Master
Development
Drainage
Plan /
Preliminary
Drainage
Report

Eagle Rising

Project No. 61145

PCD File No.: SP205

MVE PROJECT 61145
MVE DRAWING DRN-MAP-HECRAS

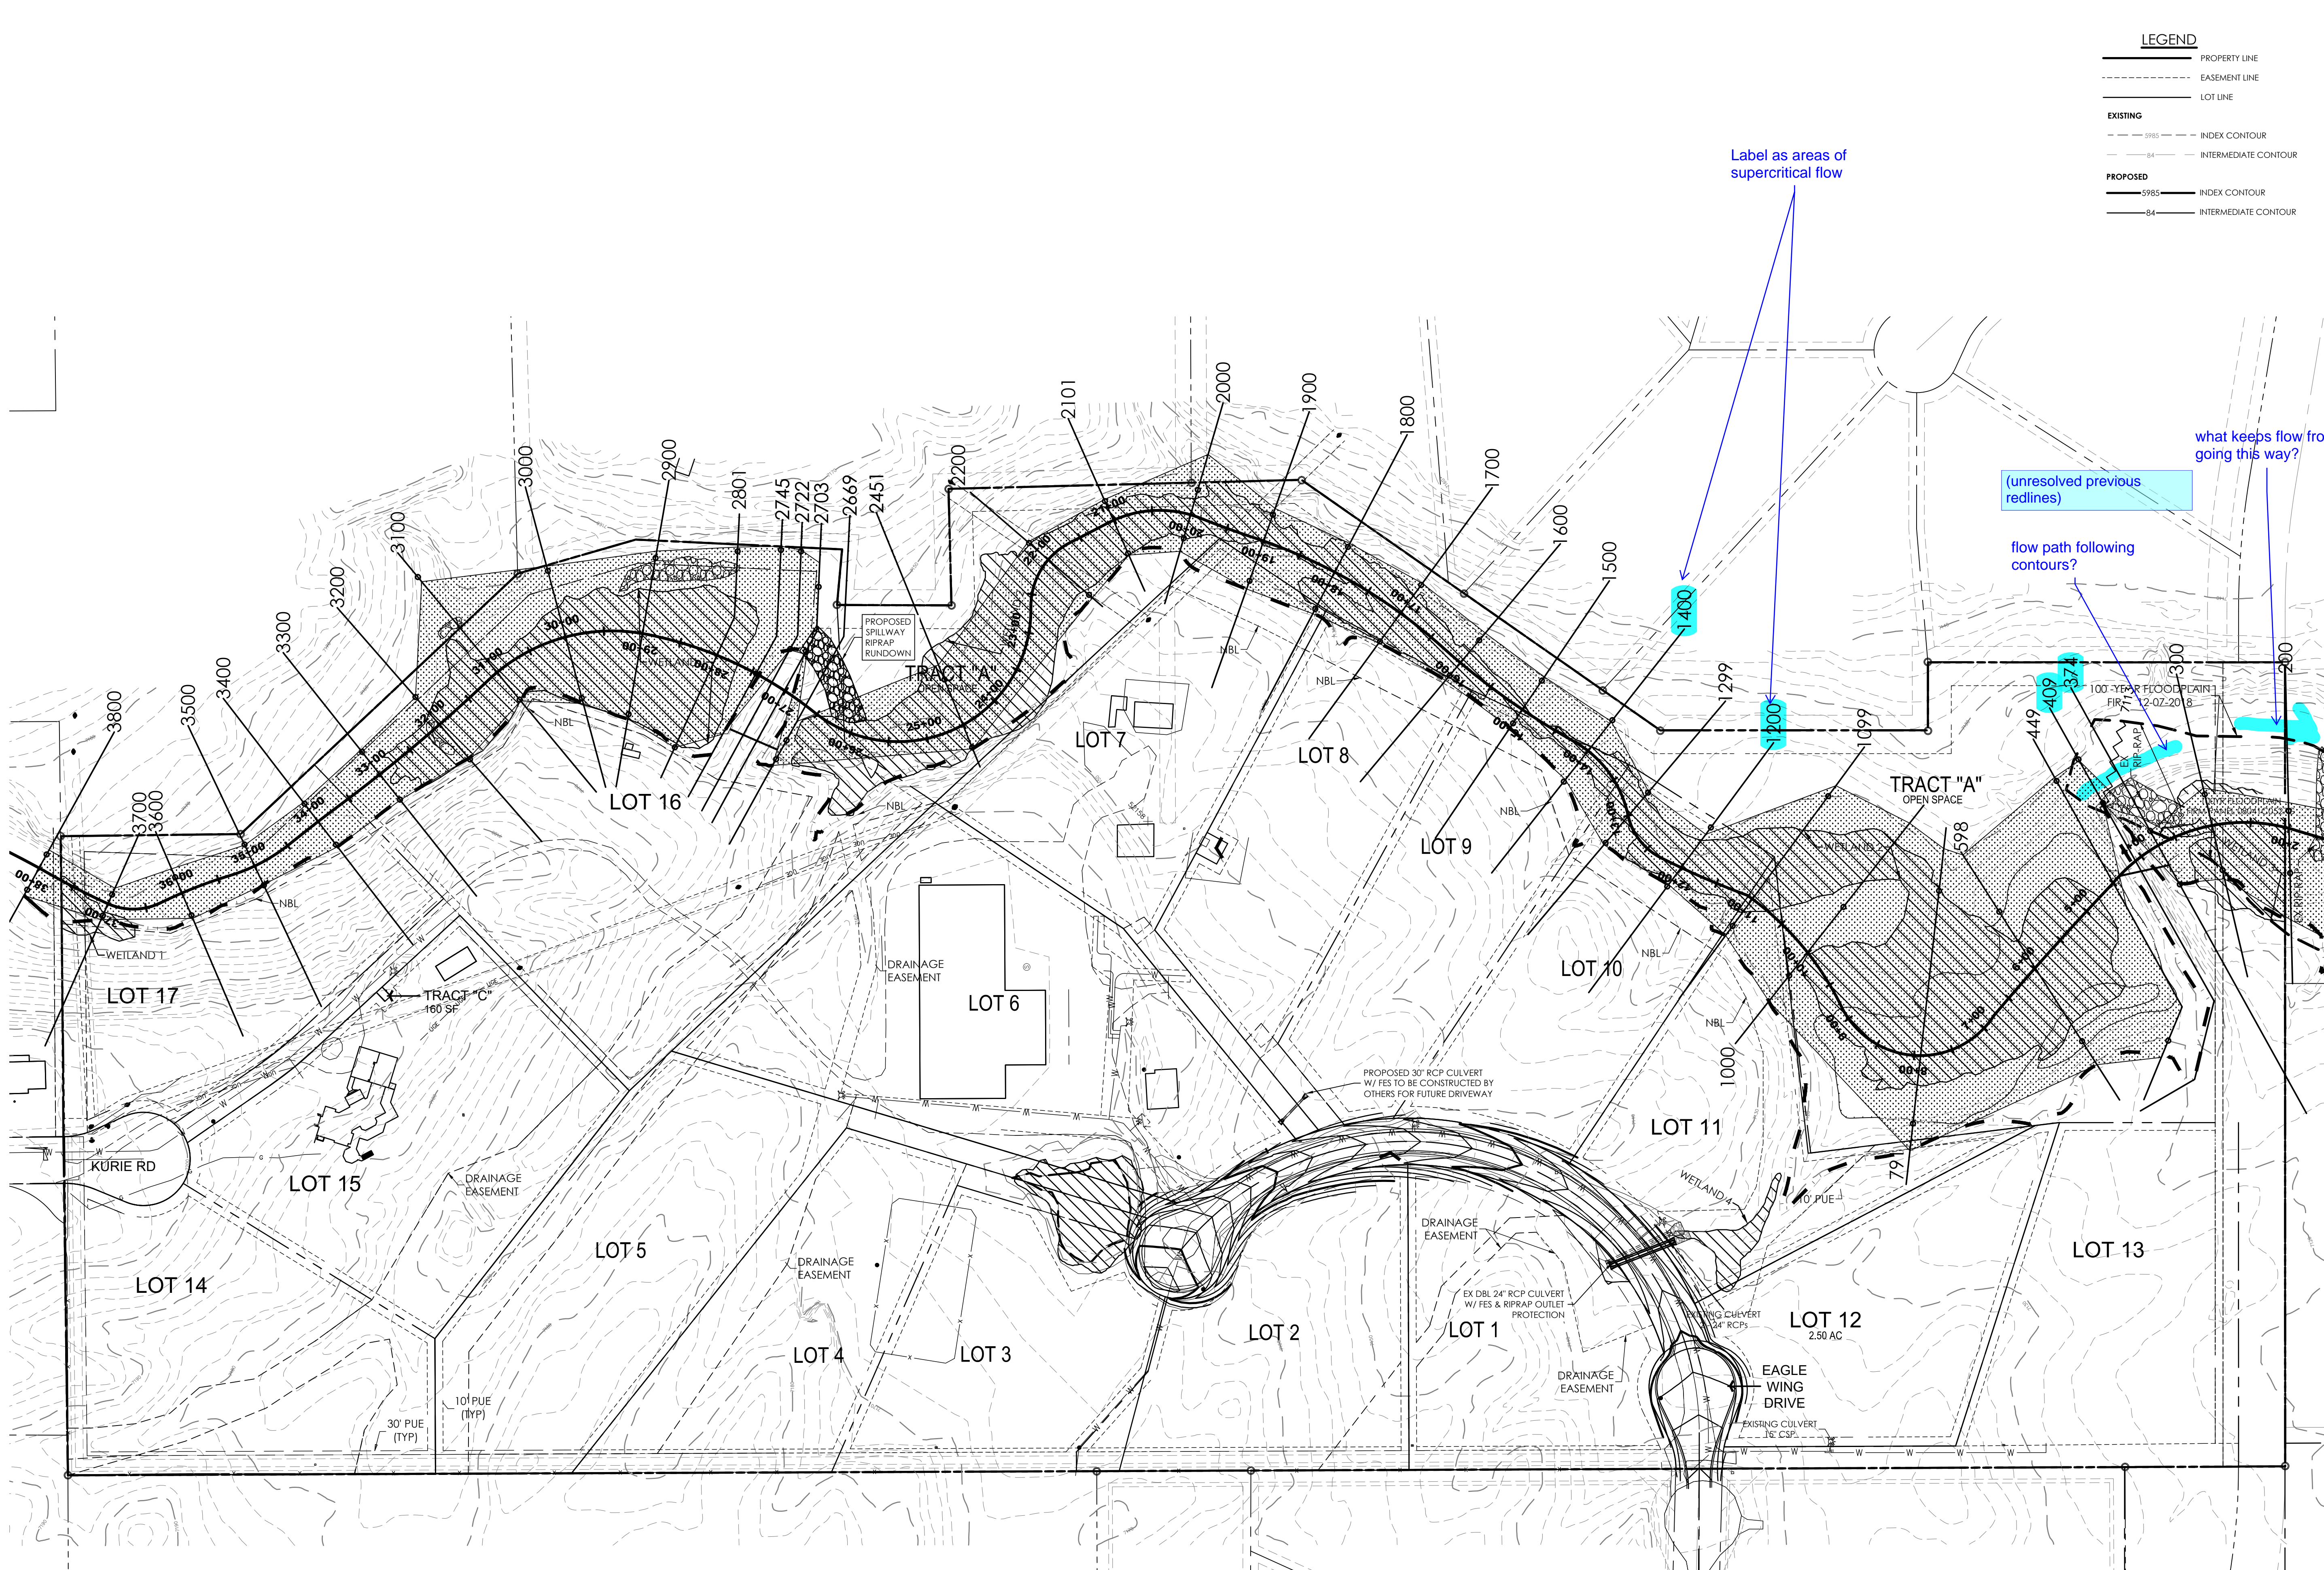
Label as areas of supercritical flow

(unresolved previous redlines)

flow path following contours?
